Hydrology and Flooding Impact Assessment

Appendix B Peer review

ILLABO TO STOCKINBINGAL ENVIRONMENTAL IMPACT STATEMENT

Figure B.1 Catchment refinement examples

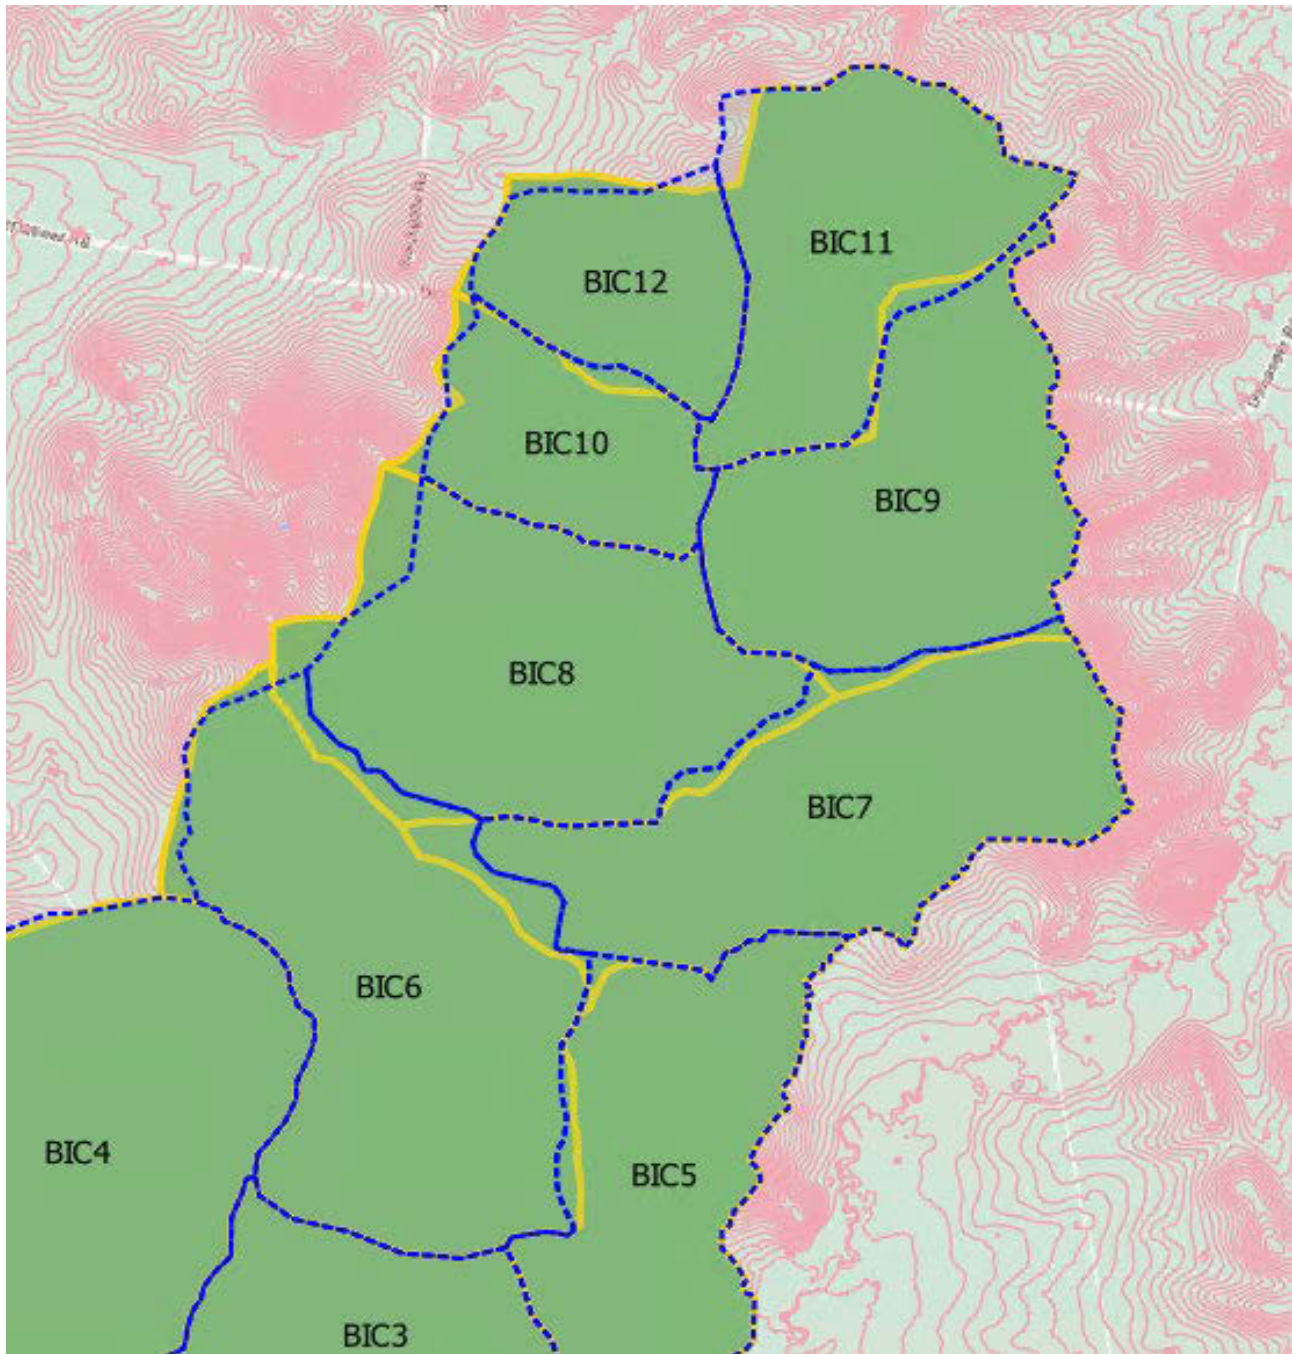
The original catchment boundaries were based on limited topographic data which was available in early 2018 and therefore limited the definition of catchment boundaries. The peer review identified areas where the proposed catchment boundaries could be improved.

In 2020, more detailed topographic data was made available through the Elvis – Elevation and Depth – Foundation Spatial Data (Commonwealth of Australia (Geoscience Australia) 2021). The catchment boundaries were then updated using the NSW Government 5m DEM data available from the Elvis foundation website. The DEMs are 2km by 2km and were captured in 2015. This data superseded the previously available 20m DEM data.

The images below includes an example of where the updates where made with the previous (blue) and refined (yellow) model boundaries.

11/6/2021 – the changes to catchment boundaries have been made and the comment is closed.

Figure B.3 Tuflow and XP-RAFTS flow hydrographs for Billabong Creek

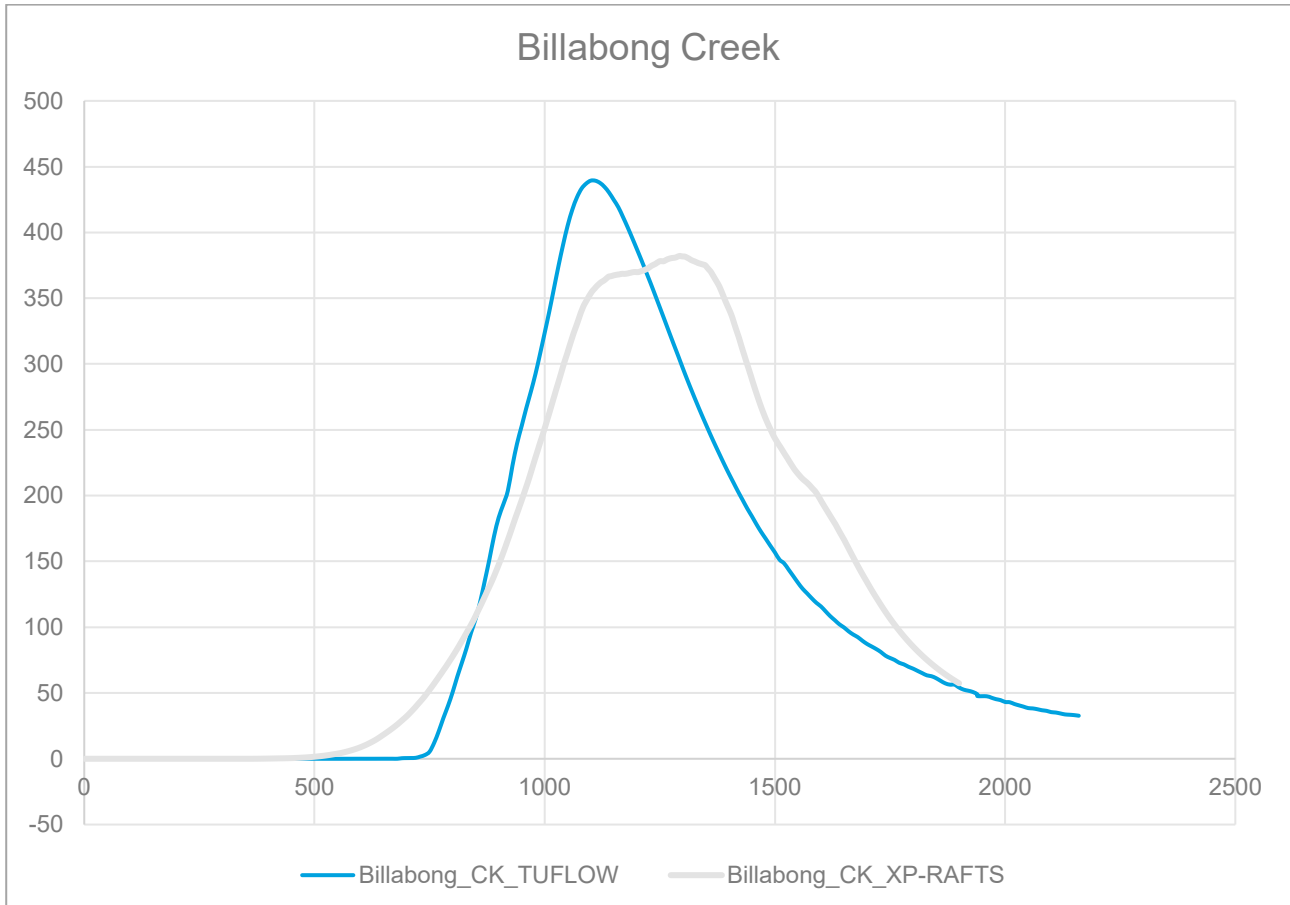
1. For Billabong Creek, peak flow estimated by the TUFLOW model closely matches the RFFE expected peak flow. For detailed design a review of the peak flow timing and flood hydrograph volume will need to be completed to ensure the TUFLOW model includes the full flood volume.

The Billabong Creek flow hydrograph has been compared between the TUFLOW model and the XP-RAFTS models to ensure the full flood hydrograph volume is being accounted for in the model. The graphs below present the evidence that the TUFLOW model includes the full flood hydrograph for a number of key locations across the proposal, including Billabong Creek.

It is therefore believed that this issue has been resolved. The flow hydrograph for the original peer review did not capture the entire floodplain flow extent. Figure B.4 below presents in green the previous PO line and the yellow line is the adjusted PO line. The resulting peak flow is now higher at a peak of 437m³/s and the volume is estimated to 14,140 megalitres for the TUFLOW model. For the XP-RAFTS model the peak flow is approximately 382m³/s with a volume of 15,700 Mega litres. It is noted that the peak flow estimates at all upstream locations where the proposal intersects the catchments are of the same magnitude. The design at Billabong Creek is constrained by the existing main southern rail tie in point.
